Serial No. **10/732,804**  
Amdt. dated July 20, 2007  
Reply to Office Action of March 20, 2007

Docket No. **P-0622**

**REMARKS/ARGUMENTS**

FIG. 4

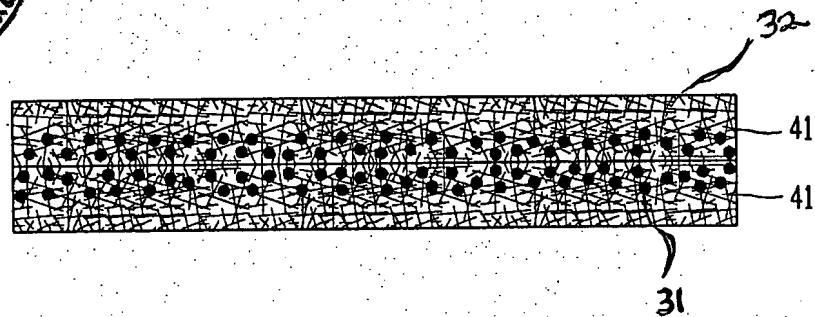
The attached drawings include changes to Figs. 4 and 6. These sheets, which include Figs. 4-7, replace the original sheets including Figs. 4-7. In Figure 4, previously omitted reference numerals 31 and 32 have been added. In Fig. 6, previously omitted reference numeral "60" has been added, and reference numeral "66" has been deleted. No new matter is added.
